Greater Dublin Drainage Project Addendum

**Environmental Impact Assessment Report Addendum:
Volume 2A Part A of 6**

Chapter 4A Description of the Proposed Project

Uisce Éireann

Diagram 4.1: Updated Proposed Project Construction Programme

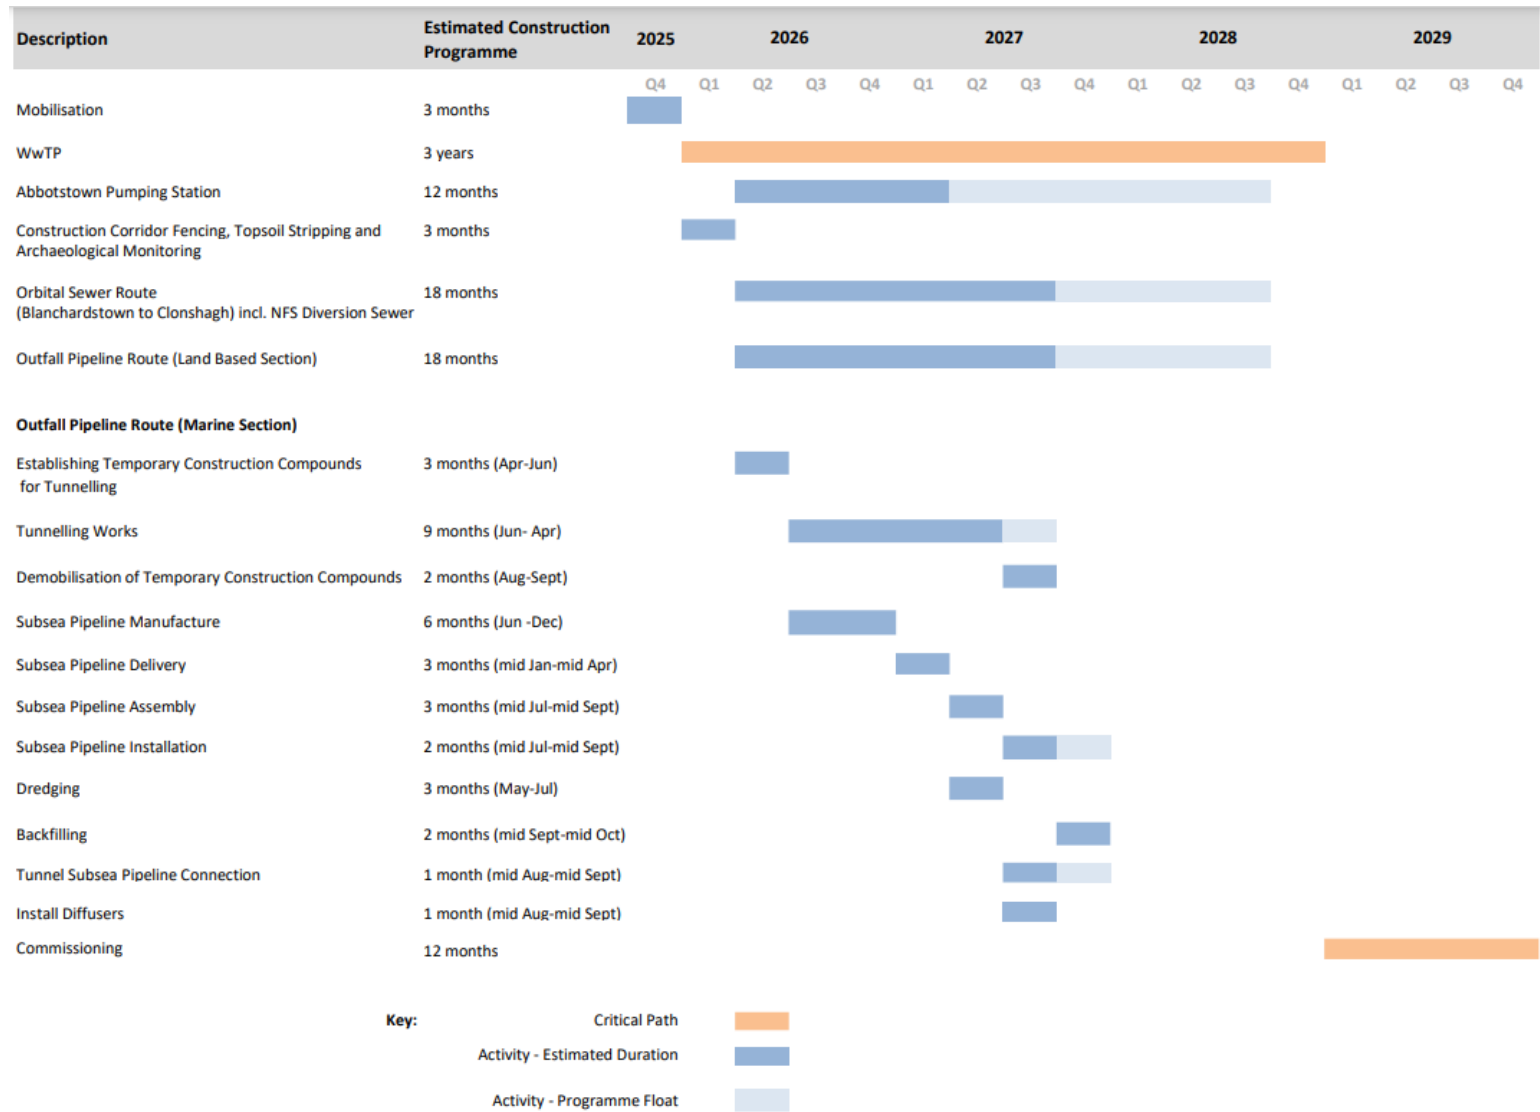
An updated estimated timeline is provided in Diagram 4.1. The total Construction Phase will remain as approximately 48 months, including 12 months of commissioning. Individual activities will have shorter durations.
